RE: St. Lucie Unit 1  
Docket No. 50-335  
Proposed License Amendment  
Supplemental Information  
Personnel Airlock Open During Core Alterations

**Proposed License Amendment  
Supplemental Information  
Personnel Airlock Open During Core Alterations**

**Figure 1A A/C Units & Fresh Air Filter Housing**

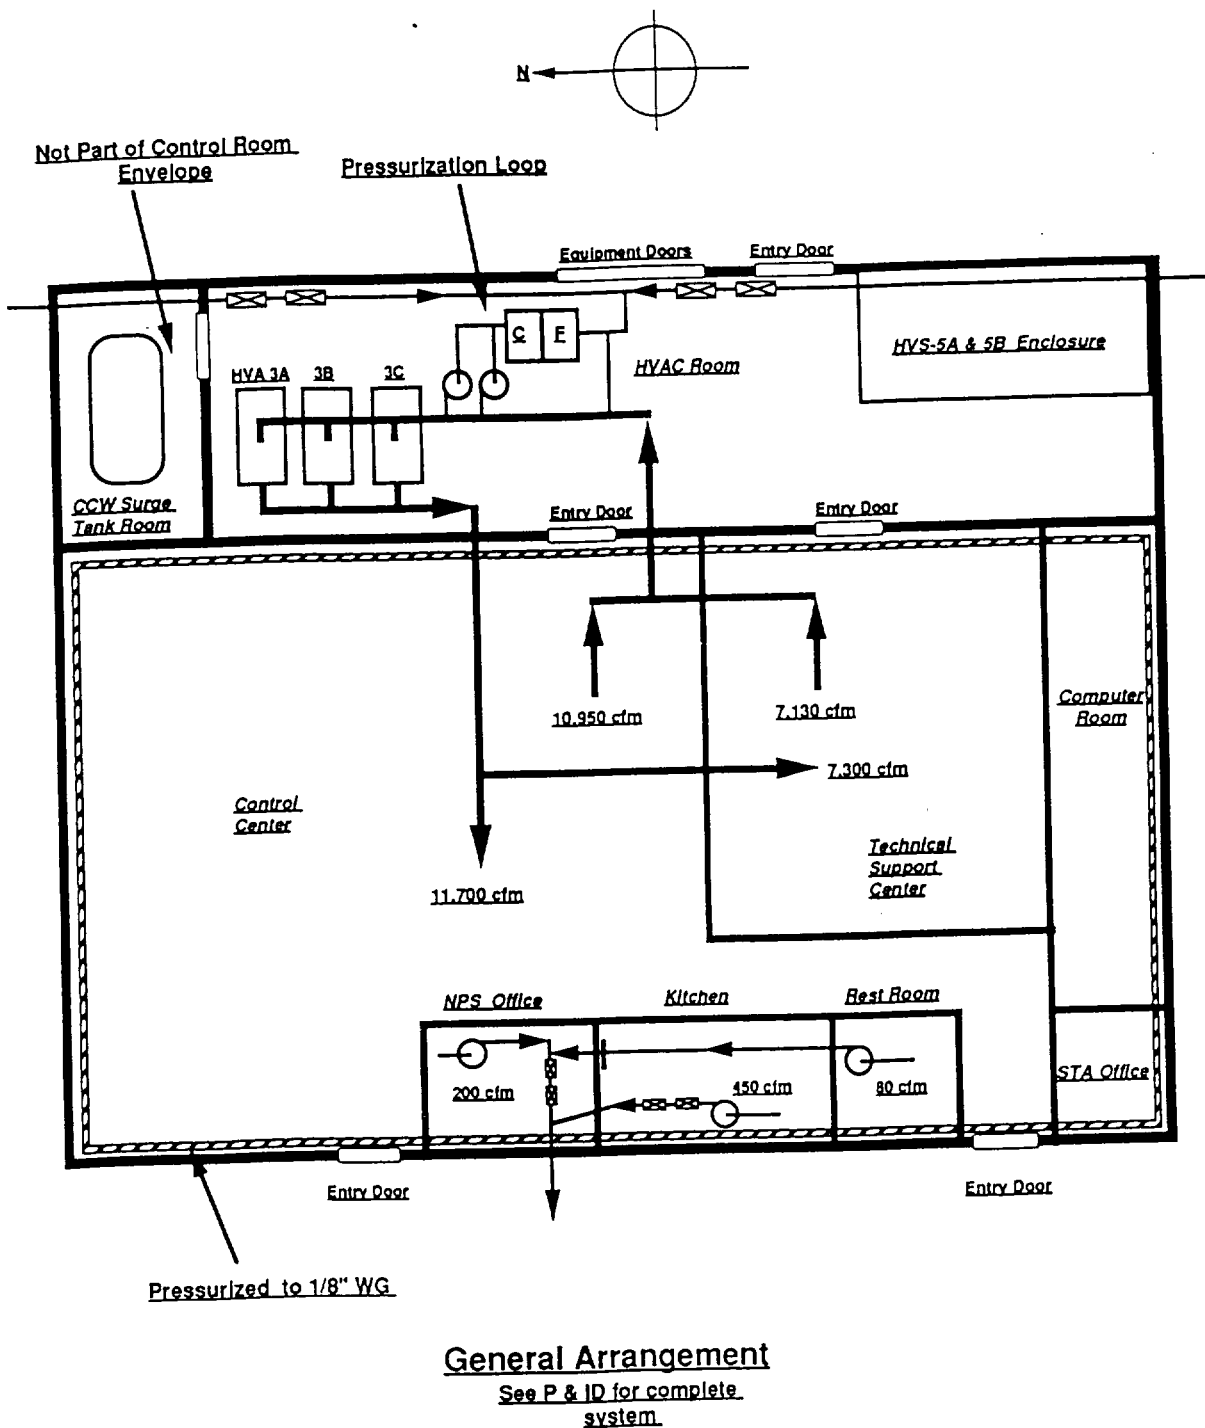
- 2) How are the connections made between the HVAC Duct work and components?

There are both welded and bolted connections. Photos are provided as Figure 1A, 1B, and 1C to show the general arrangement of this system and its connections. These pictures show an air conditioning (A/C) unit, the pressurization filter, and charcoal filter housing. Two views of the pressurization fans and duct work. They are joined to the filter housing directly via a bolted connection.
